PRODUCT NEWS BULLETIN

PN154080906

Revised and re-issued June 27, 2008

**Product Improvement
Hardened Wire Swivel Races**

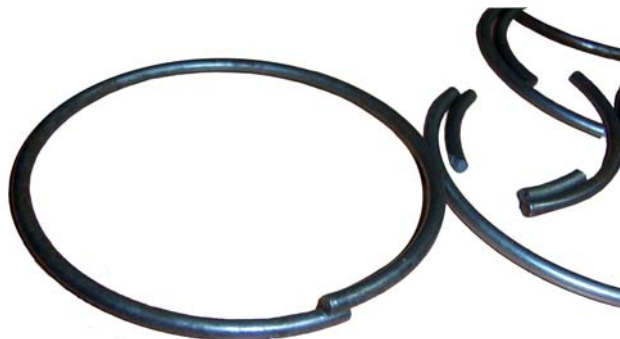
Since its design inception in 1982, Carter's Model 61154 Dry Break Quick Disconnect has incorporated hardened wire races, part number 207364, (*item 6 of Figure 2 in Service Manual SM61154) on the male half of the swivel/disconnect to ensure resistance to wear created by the stainless steel latching balls. The more recently developed Model 64254 Low Pressure Drop Dry Break Quick Disconnect and Model 64155 Continuity Dry Break also feature the same hardened wire races (*item 27 of Figure 3 in the Service Manual SM64254 and item 3 of Figure 3 in SM64155). The material of these wire races was changed in 1989 to 440C per AMS 5630, which is a material with higher yield strength and one that could be heat treated to C58 Rockwell. This improvement resulted in even more resistance to wear but also has a possible down side. It is extremely difficult to control the passivation treatment of parts made from 440C. Passivation is an acid etching process that cleans the exterior surface of any carbon deposit to prevent minor corrosion. Improper passivation treatment can make high carbon grade stainless steel susceptible to hydrogen embrittlement.**

Hydrogen embrittlement makes the metal very brittle and will manifest itself in wire race rings that are fractured or broken, possibly in several different places. When the race rings are fractured the ball bearings that ride on them will no longer run smoothly, making the swivel difficult to rotate.

Knowing that many airports around the world are located by the sea, Carter has decided to change the material of these wire races to 17-7 pH corrosion resistant steel per AMS 5673 and hardened to C49 Rockwell. These new wire races will be passivated and, due to the high chrome and nickel contents of this high strength stainless steel, they will be less susceptible to hydrogen embrittlement.

*"Inspect the race rings (*item xx, fig. xx) for wear or damage. Remove and measure the wire diameter in several places around its circumference. If the wire diameter is found to be less than .104 (2.64 mm) inches the ring should be replaced. Also inspect for cracks, which could result in breaks, by removing the rings from the Adapter. Removal of affected race rings is likely to result in breakage of the rings."*
